Docket Item # 13 & 14  
BAR CASE # 2015-0189 & 190

BAR Meeting  
October 7, 2015

**ISSUE:** Buildings 1 and 2  
**APPLICANT:** RTS Associates, LLC  
**LOCATION:** 2 Duke Street  
**ZONE:** W-1 / Waterfront

**BAR 2015-0189 and 0190: 2 Duke Street/Robinson Landing**

# BUILDING 01 OVERALL ELEVATIONS

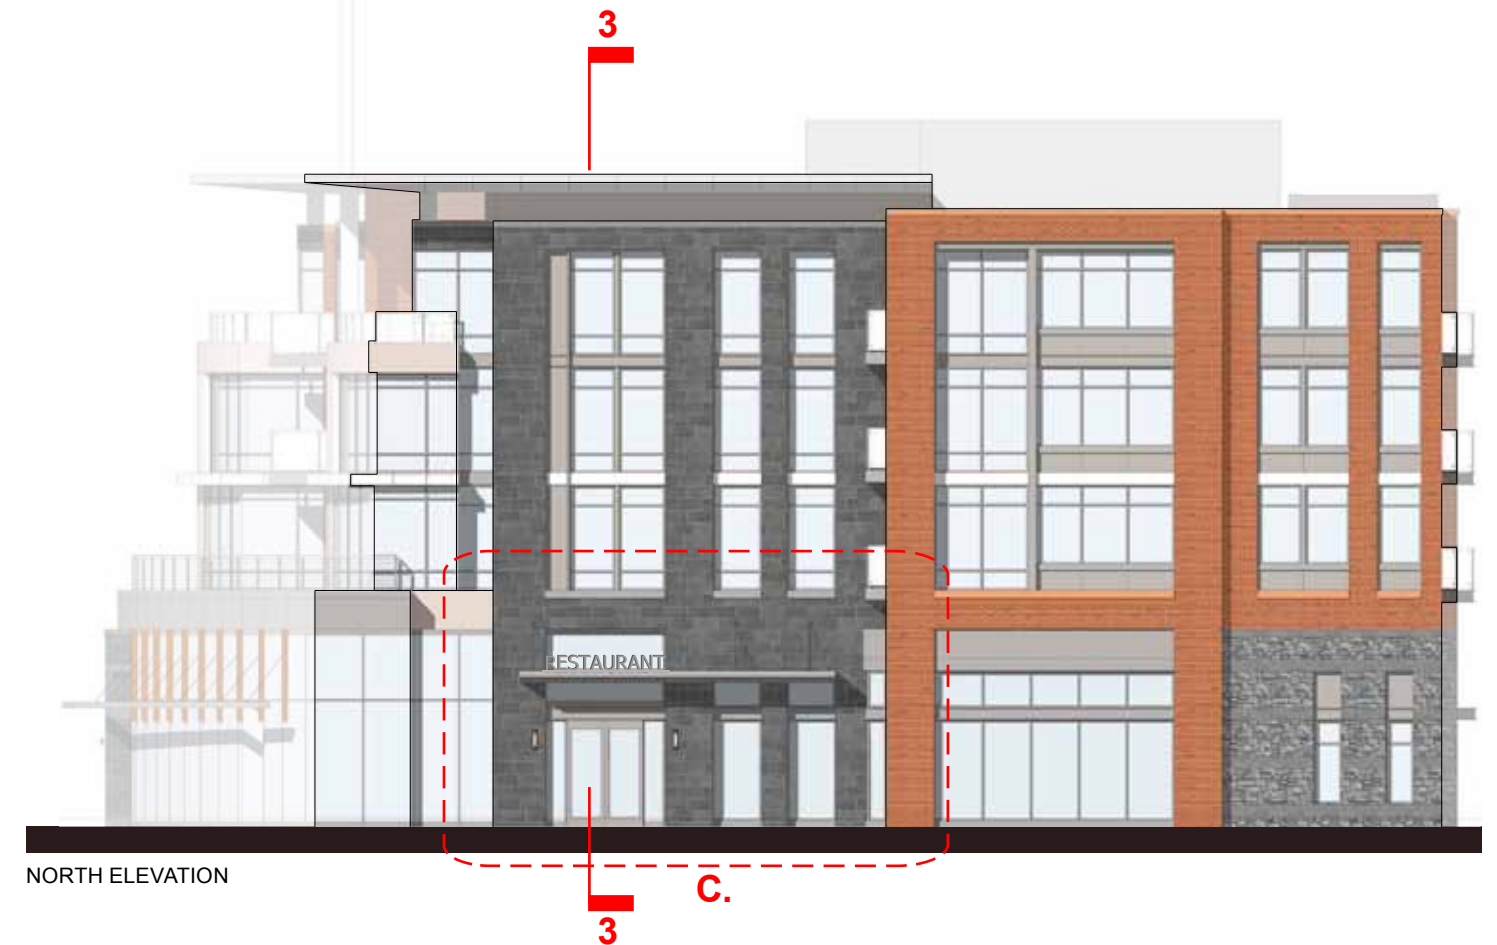
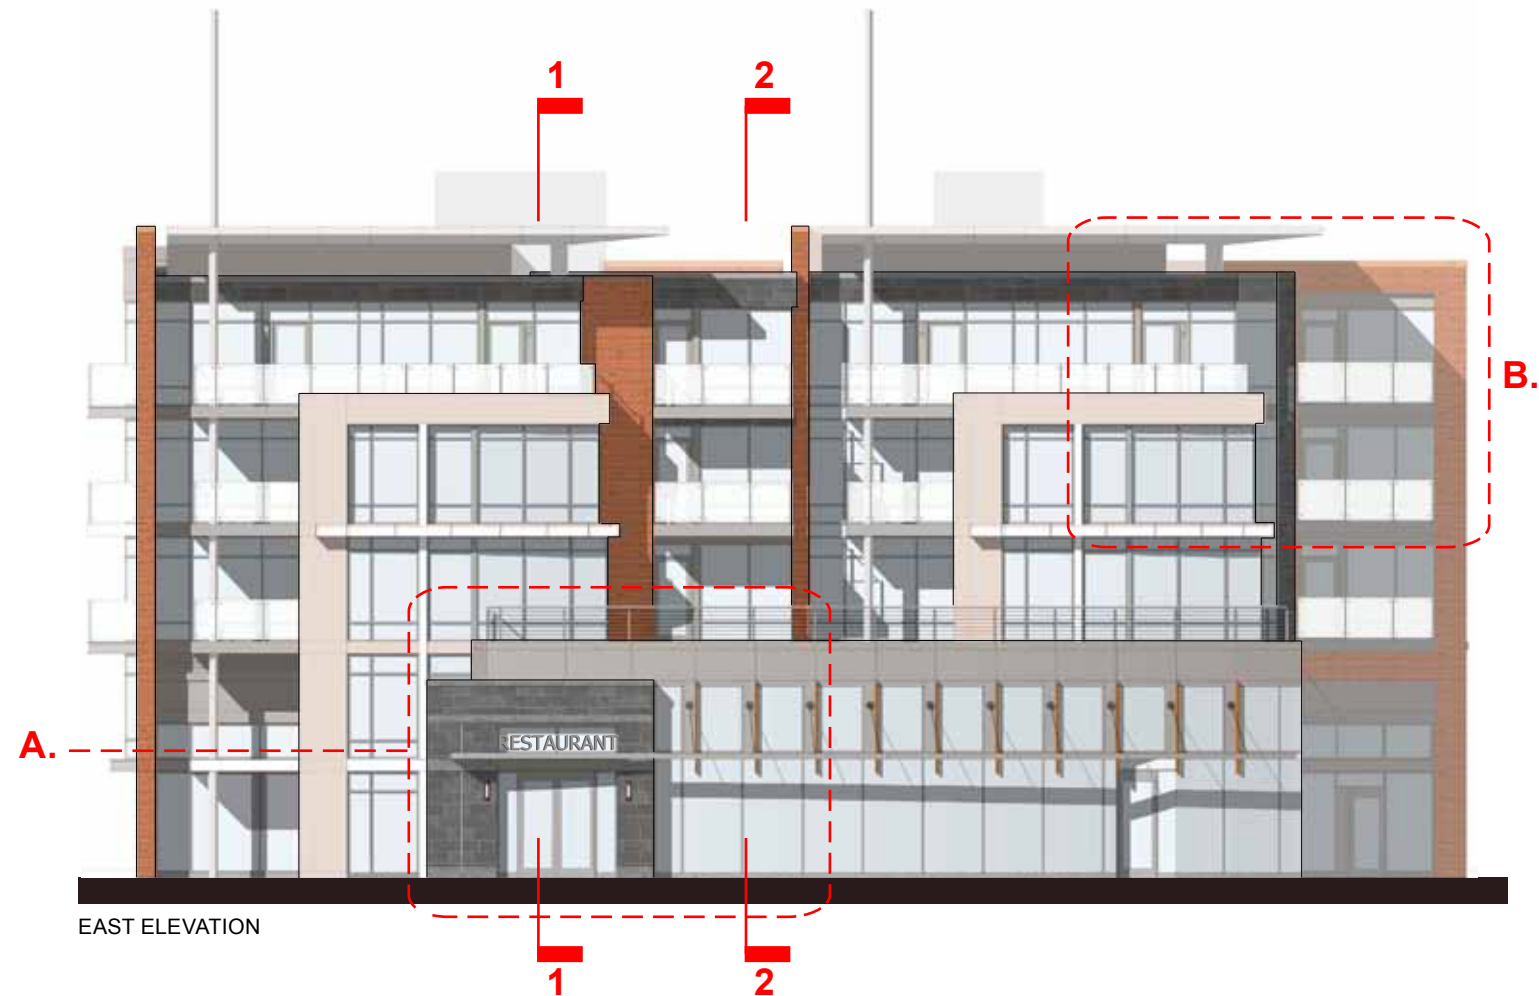
Use a rougher stone, similar to what historically was used on the waterfront such as at Fitzgerald's Warehouse AND Eliminate the "gap" between the stone base and brick on the west elevation of Building 1

These two comments have been addressed and can be seen in a detail of the west elevation of Building 1 as shown in Figure 4. The current scheme shows the elimination of the gap that previously had a shadow line and a steel beam. The rough stone, which will be subject to final approval on the materials board and a mock-up on the field, has been proposed with bands of thermal-finished stone. Staff finds this a successful way to incorporate a historically sourced material in a balanced way. Staff will work with the applicant to confirm that the rough stone will have a mix of tan/beige and grey stone, similar to the color composition of the exposed foundation at Fitzgerald's Warehouse.

**Figure 4. Detail of west elevation of Building 1 from Sheet 20.**
